September 29, 2026

Re: Construction of a New Desalination Plant at the Allen Kapolak Marine Laydown Area for 2AM-BRP1831.

Figure 2: Locations of Existing and New Desalination Plants

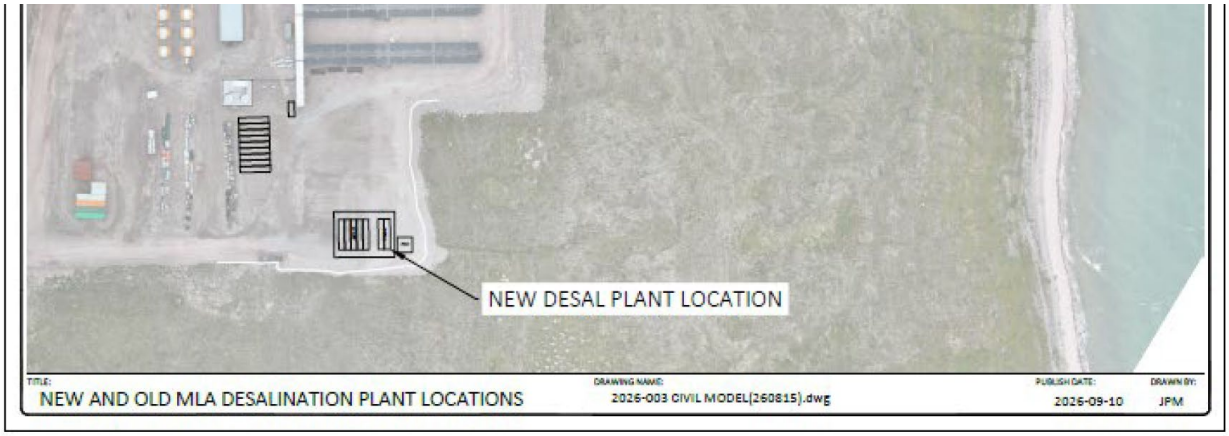
- Location; Figure 2 of the B2Gold memo "construction of a new desalination plant at the Allen Kapolak Marine Laydown Area" dated September 19, 2026, shows the desalination plant to be located on the existing gravel pad:

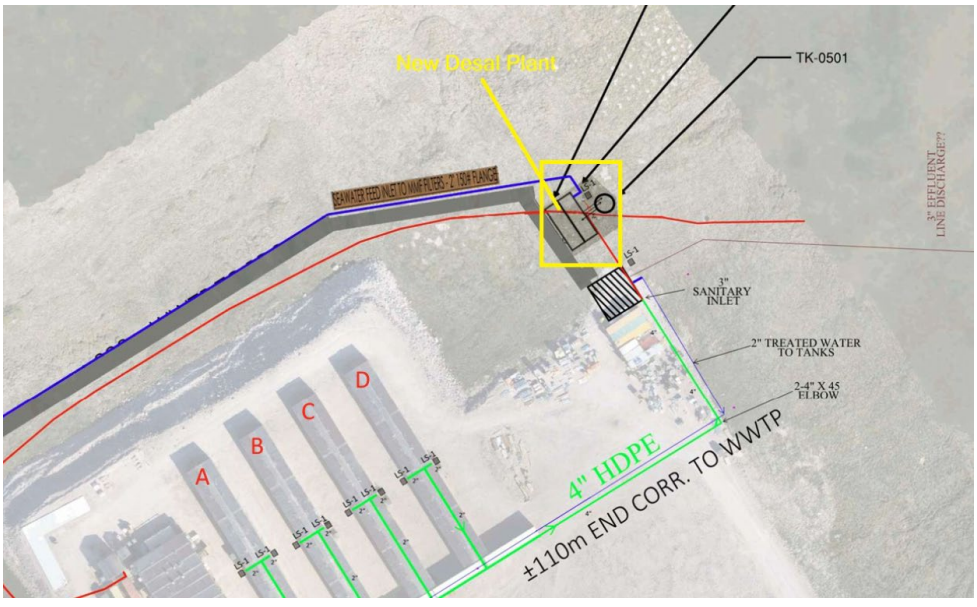
- However, drawing "260910 2AM-BRP1831 Desalination Plant at the MLA B2Gold Response Drawing-IMLE" (2026-03-24) does show the plant to be outside the existing gravel pad, directly located on the tundra (see screenshot below). This location is not acceptable and B2Gold should confirm where the new desalination plant is located.
